Attachment B

**Figure 2-1. Sampling Locations Under the ERM Program (U.S. Army 2000a)  
Jefferson Proving Ground, Indiana**

2002 Decommissioning Plan

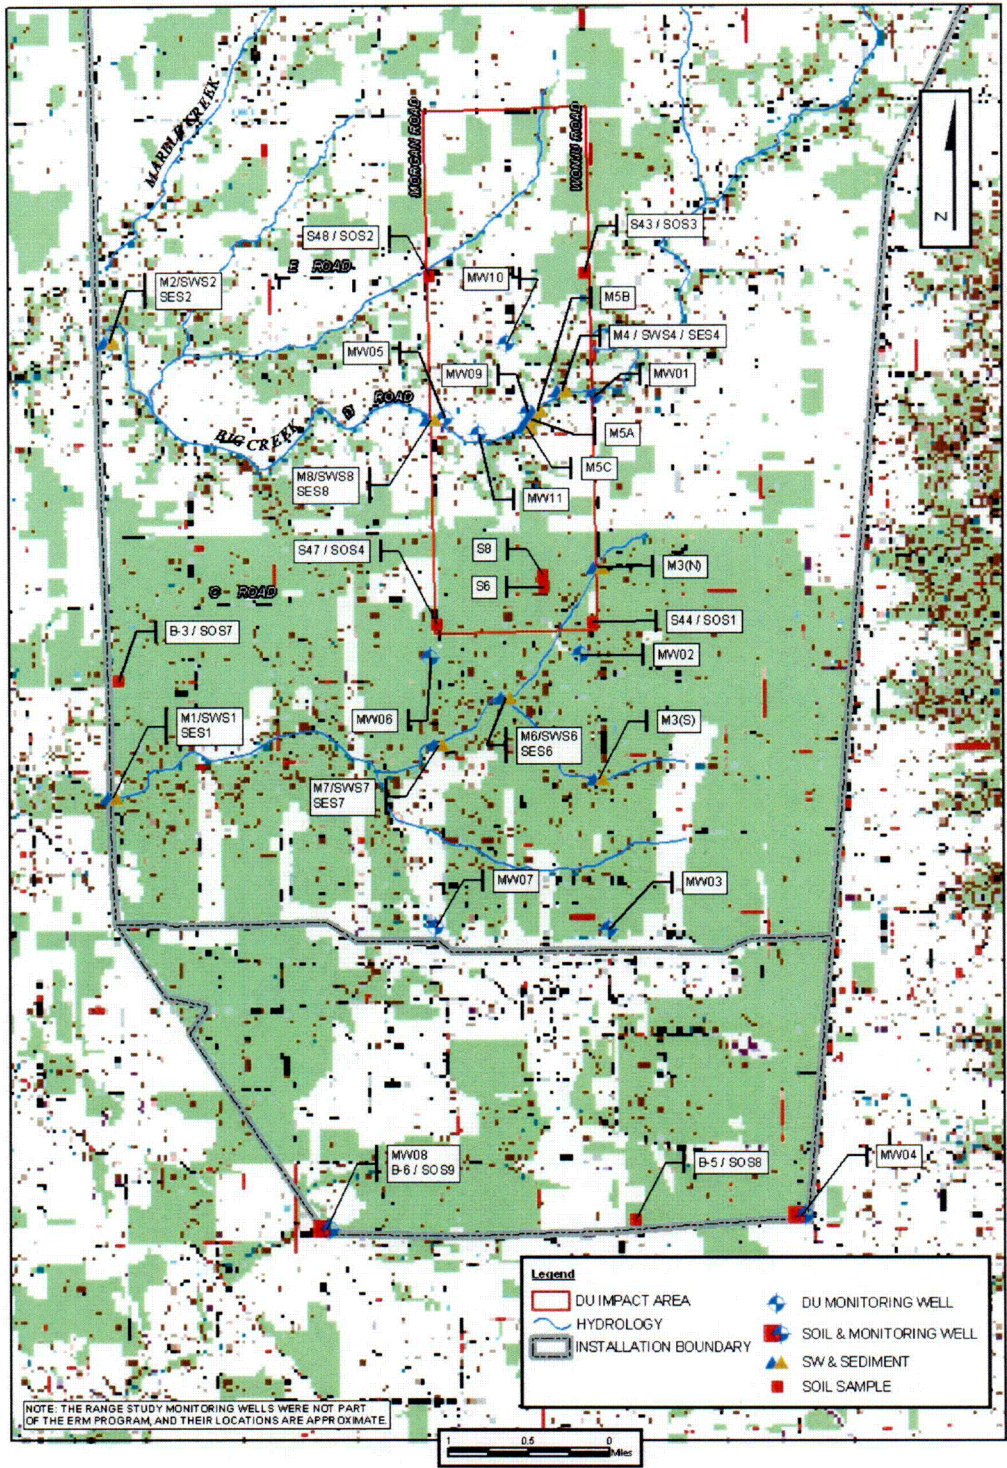
- The boundaries of the DU Impact Area are depicted in Figure 2-1 (*DQO Step 4 – Define the Study Boundaries*).
- Contaminant concentrations at JPG ERM sampling locations will be compared with the concentrations detected in appropriate background media and specified in Federal regulations or defined in this ERM Program Plan to determine the extent of contamination migration at JPG (*DQO Step 5 – Develop a Decision Rule*).
